## LINCOLN CITY/LANCASTER COUNTY PLANNING STAFF REPORT

for March 16<sup>nd</sup>, 2005 PLANNING COMMISSION MEETING

**P.A.S.:** Foreman Ridge Addition, Special Permit # 05002, Community Unit Plan

**PROPOSAL:** A Special Permit/CUP for 29 lots, including 76 Build-Through lots, generally located at S. W. 12<sup>th</sup> Street and W. Denton Road.

**Special Permit #05002**  
**Foreman Ridge Add CUP**  
**SW 12th & W. Denton**

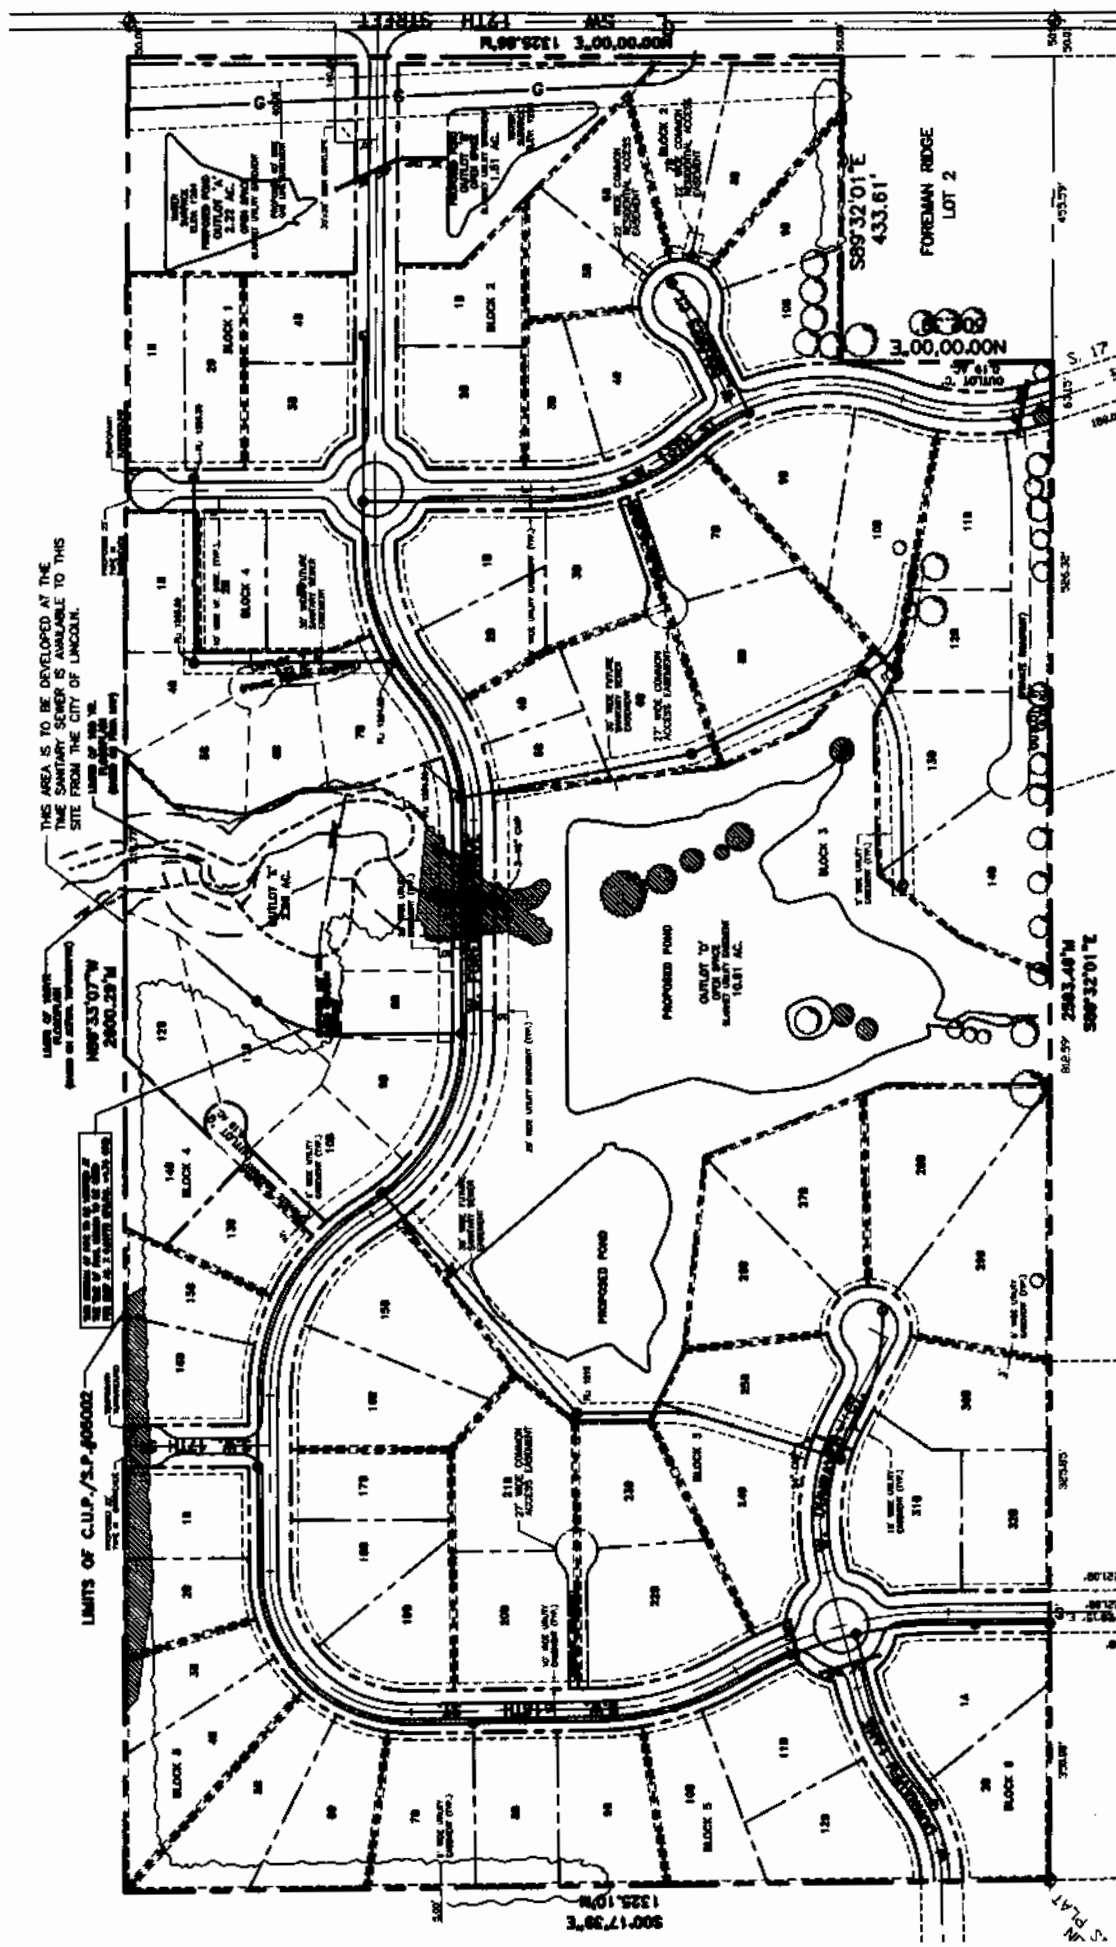
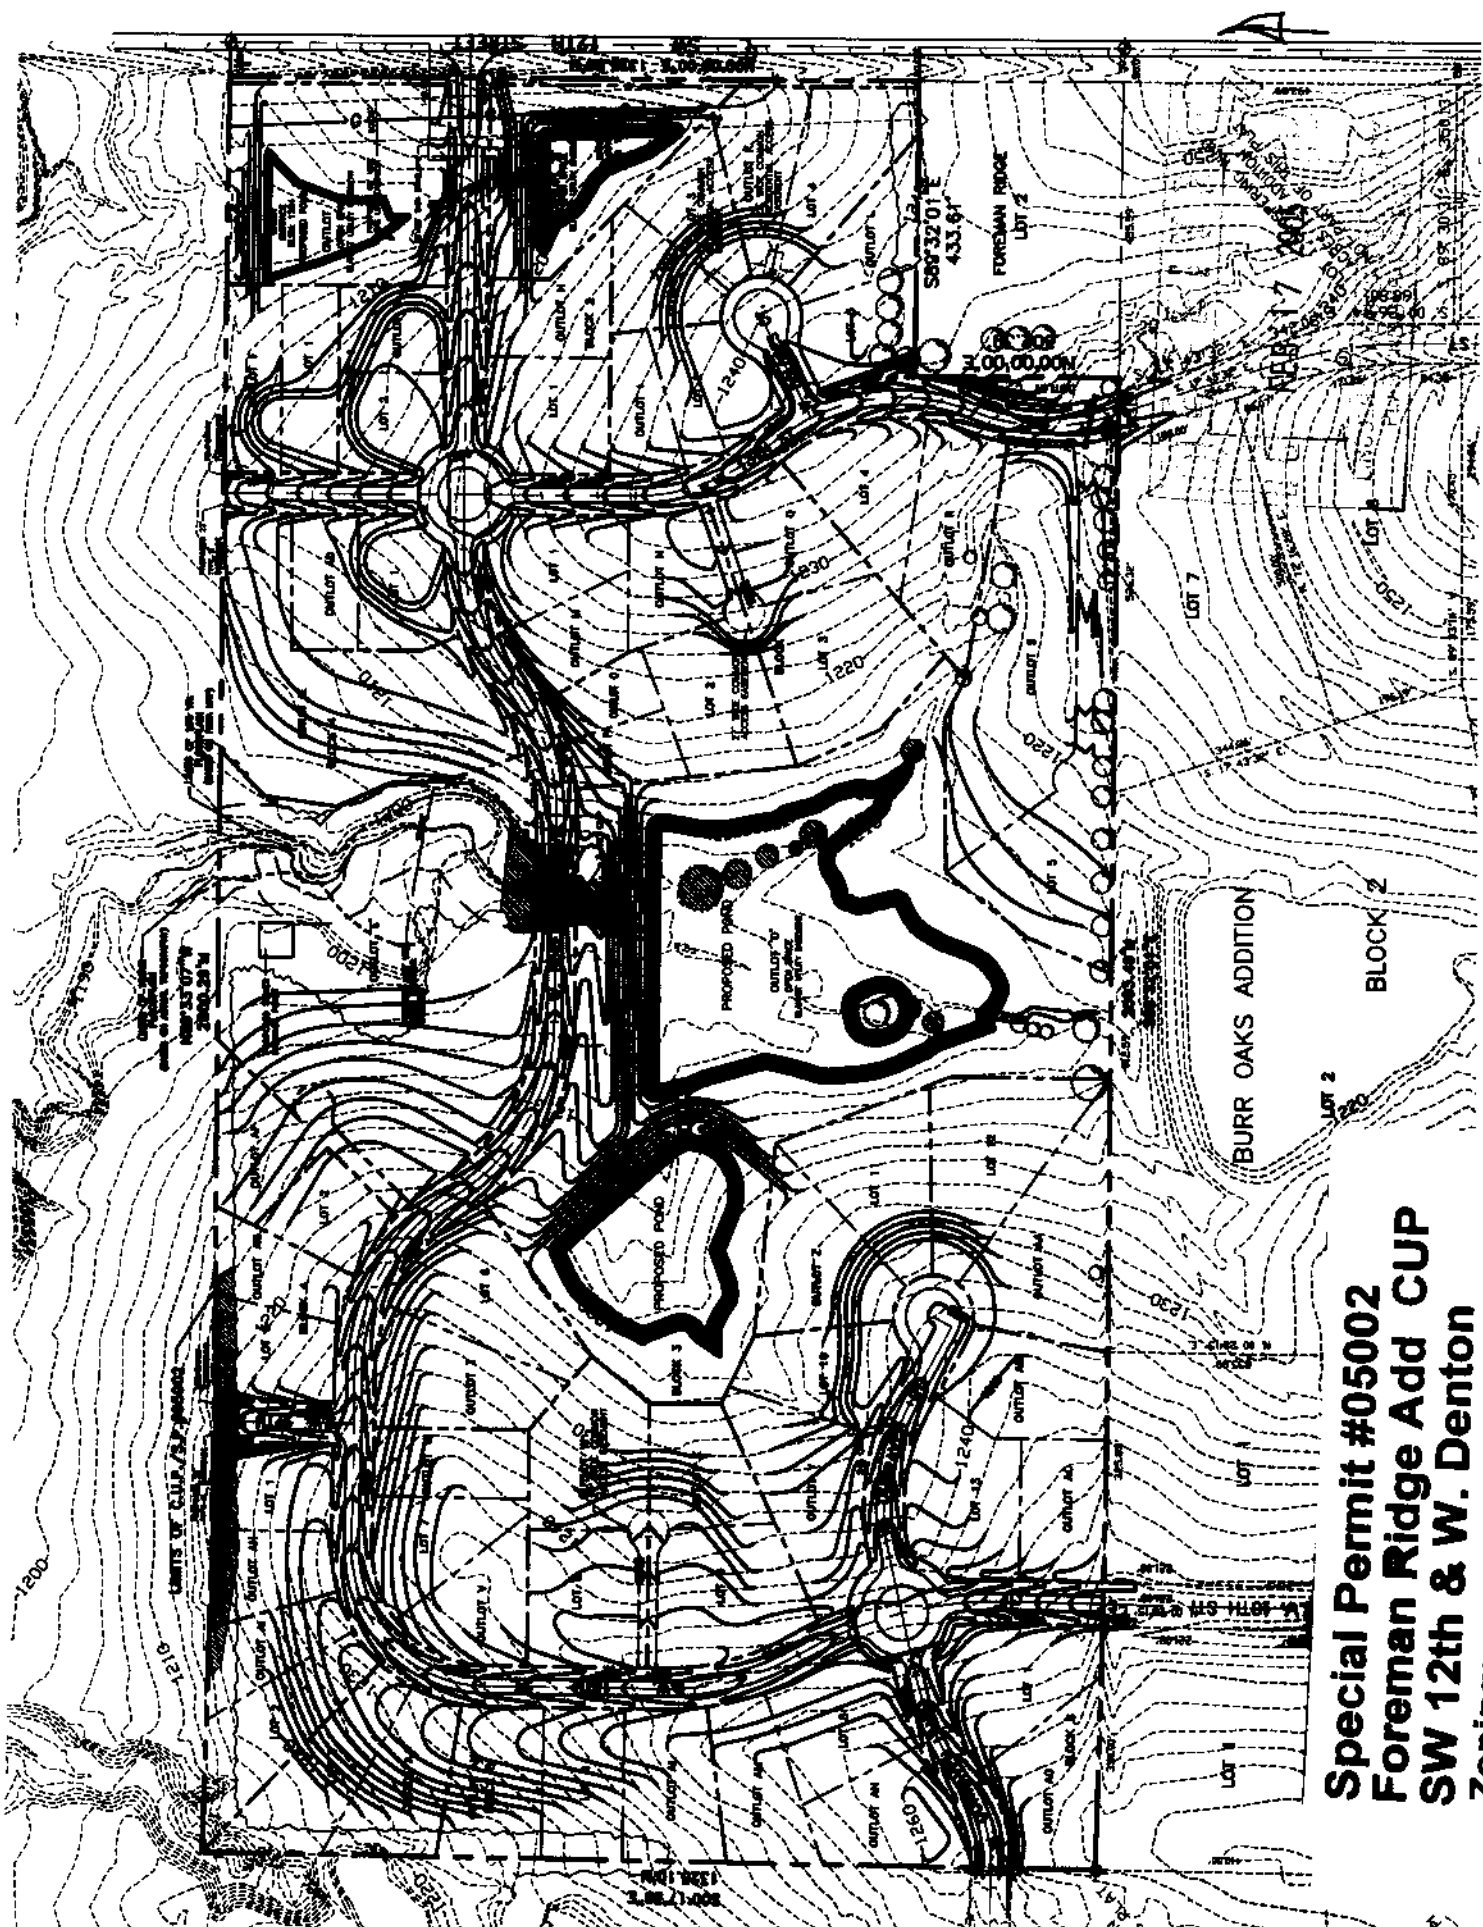
5.1.3 Note the purpose of Outlot "C".

5.1.4 Revise Note #3 to reference the community sewer system.

5.1.5 Amend Note #7 to reflect the "Rural Public and Intermediate BTA Standard" and the City of Lincoln.

5.1.6 Add a note that this is designed for future platting to a density of about 76 dwellings and for future subdivision of the acreage lots.

5.1.7 Revise Note # 5 to remove the statement, "Lagoons shall not be prohibited if a septic system can not be approved".

5.1.8 Show grading for the future private roads.

5.1.9 Provide a drainage easement along the creek.

5.1.10 Show the easements requested by Norris Public Power.

5.1.11 Show the petroleum pipeline easement.

- 1) General Note 15 shall be revised to allow plants, shrubs or vegetation in the round-abouts, but in no case shall the plantings encroach on the traveled way and shall be no higher than 3.5 feet above the elevation of the traveled way.

- 2) The profile of SW 17<sup>th</sup> Street requires an extreme amount of fill when the street is extended for a future development. This condition is not reasonable.

- 3) The connection of West Dunraven Lane and West Dunraven Court to SW 18<sup>th</sup> Street is not acceptable. The approach profiles do not intersect with the proposed profile of SW 18<sup>th</sup> Street.

- 4) The elevation of the middle of the round-about at Culvert A is 1,248.62 which is only 1.62 feet above the 24" culvert inlet.
- 5) The low point of the road for Culvert B should be 1,246.80 which is only 1.80 feet above the 24" culvert inlet.

- 6) The headwater for Culvert D is within 0.24 foot of the road centerline elevation. The headwater should be below the shoulder elevation.
- 7) The low road elevation for Culvert E is shown as 1,208.50 in the HY-8 analysis and is shown as 1,206.45 on the street profile. This culvert should be redesigned.

- 8) Additional details shall be submitted for the round-abouts. Details shall show what size vehicle can use the round-about and provisions for drainage.

(1.1) Easements need to be shown for the possible location for the future sewer extensions required to serve this plat.

(1.2) The alignment of the future sanitary sewer along the east side of Outlot D is unsatisfactory. The alignment needs to be revised to show 90 degree or less angle. Also, sizing calculations need to be provided showing that the future eight inch sewer will be sufficient to serve all the land upstream to the south of this plat.

(3.1) The requested waiver of design standards for detention is not necessary as the proposed land use will not increase the storm runoff. However, additional information is required concerning the proposed ponds. If the ponds are to be built with this plat information needs to be provided concerning the outlet works for the ponds. Information needs to be shown how the pond in Outlot B and the main pond in Outlot D will function with the road culverts directly down stream.

(3.2) Easements need to be shown for future storm sewer that will be required to drain the cul-de-sacs and other sump conditions in the streets. Also, the grading and flowage easements need to be shown to ensure that the drainage paths stay open.

(3.3) Minimum opening elevations need to be provided for all lots that will be adjacent to the proposed ponds.

(3.4) A flood corridor easement needs to be shown for the portion of the portion of the channel that drains more than 150 acres and is not part of the mapped flood plain.

(3.5) Labels for the proposed culverts need be provided to match the locations on the plans to the analysis in the culvert sizing report before a proper review can take place.

(4.1) As shown there are numerous locations in this plat that shows intersection platform grades exceeding the maximum grades allowed by design standards. The profile grades need to be revised to meet design standards or a waiver of design standards for intersection platform grades needs to be requested and justified.
